DOE Project Execution Plan

**Run IIb CDF Detector Project
and
Run IIb D-Zero Detector Project**

**Revision 1.1
May 27, 2005**

Revisions for PEP Version 1.1

**Figure 5.2
Revised D-Zero Work Breakdown Structure**

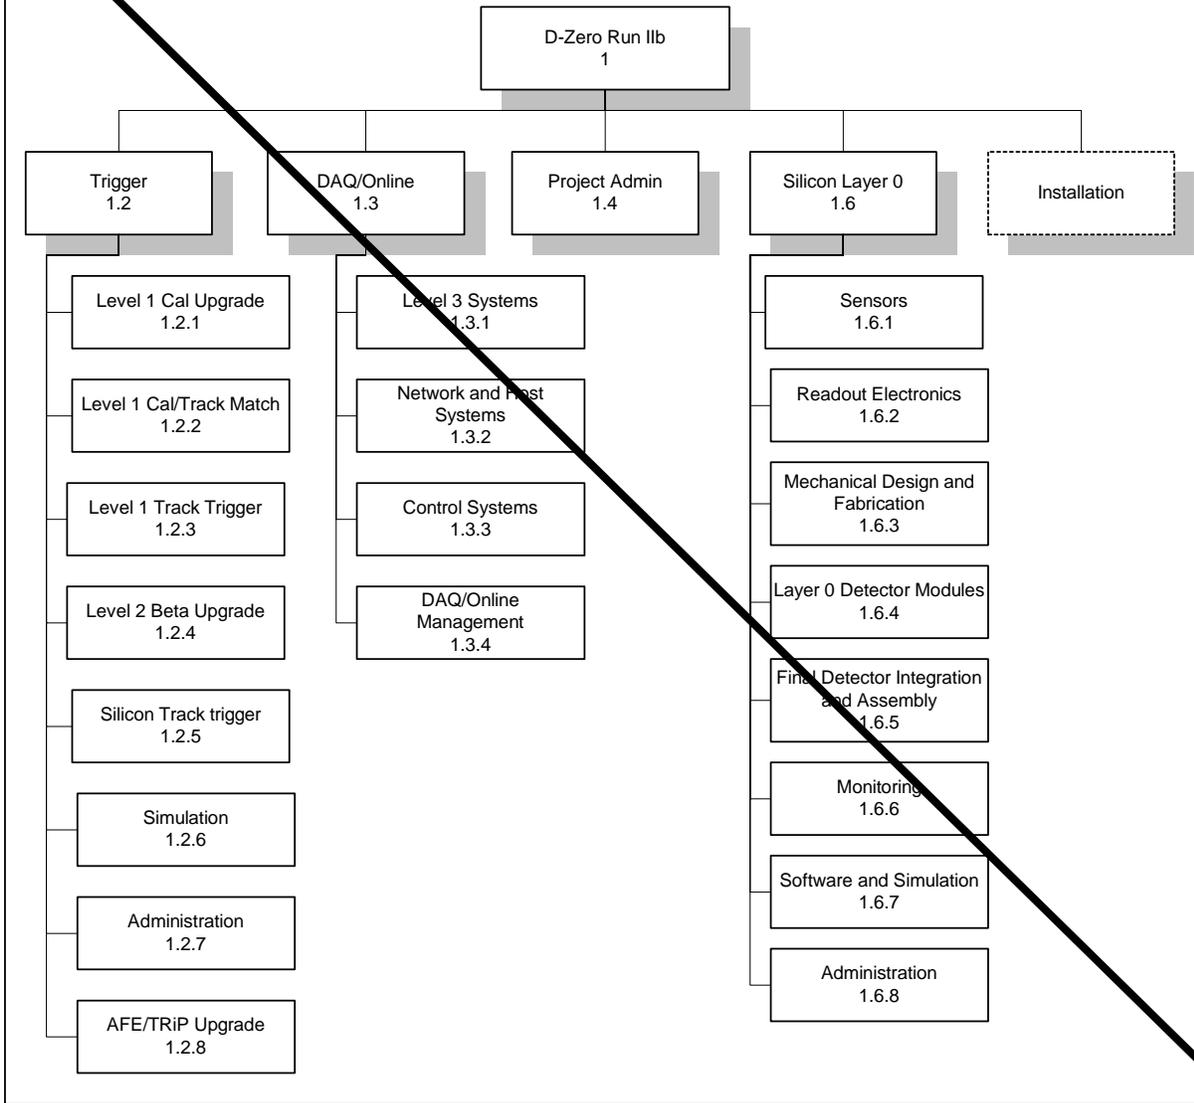
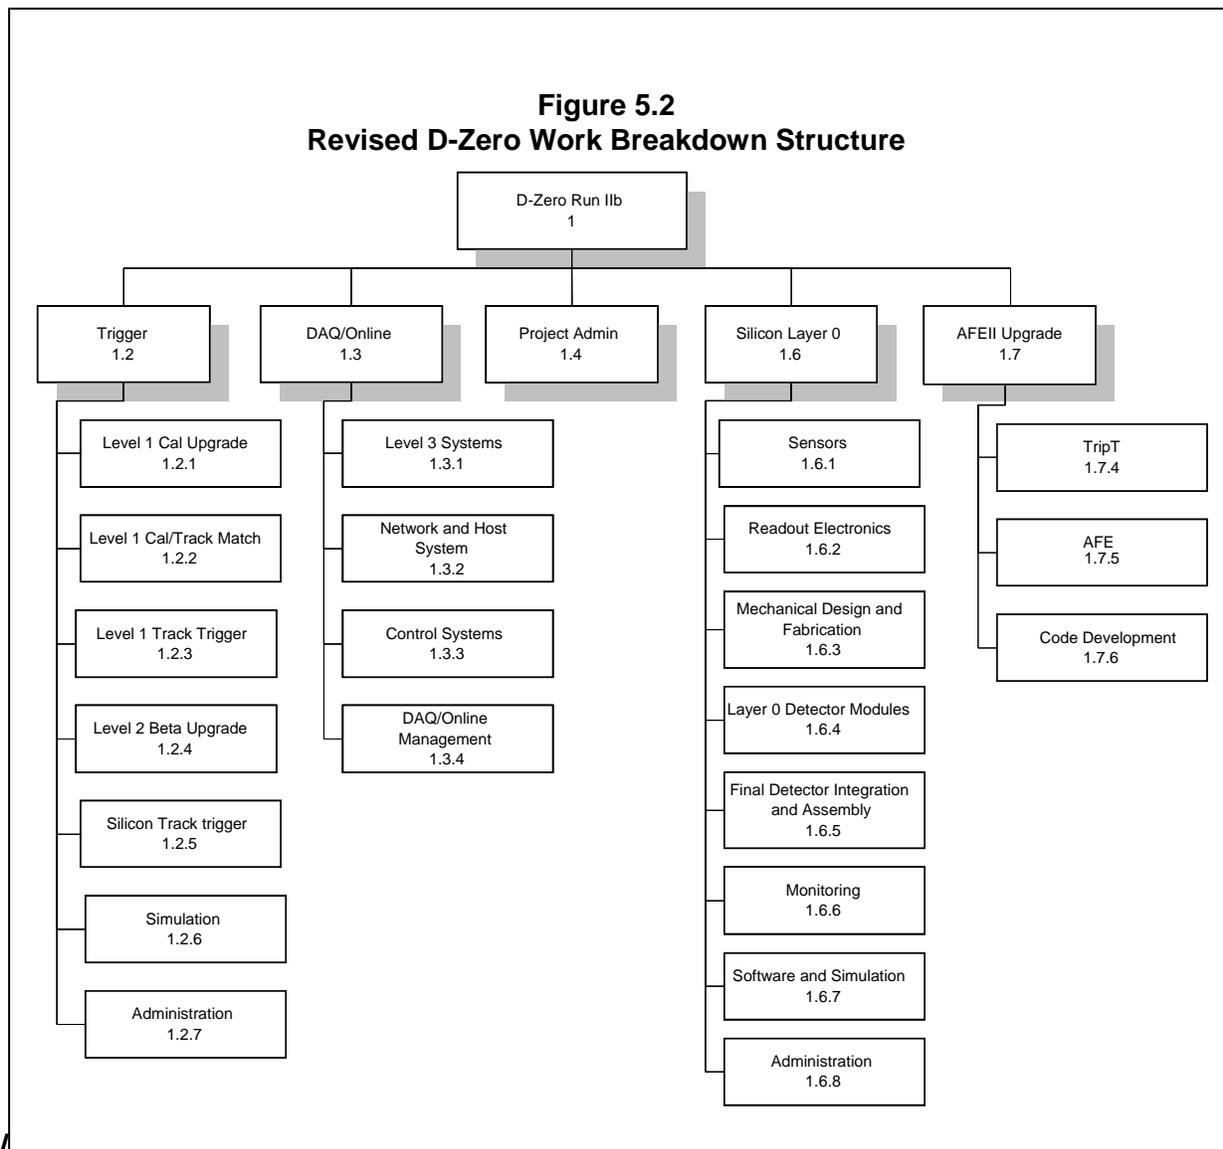
Per Change Proposal DZero—003, the following figure and table were revised.

- Figure 5.2, D-Zero Work Breakdown Structure
- Table 7.4, Level 1 Milestones
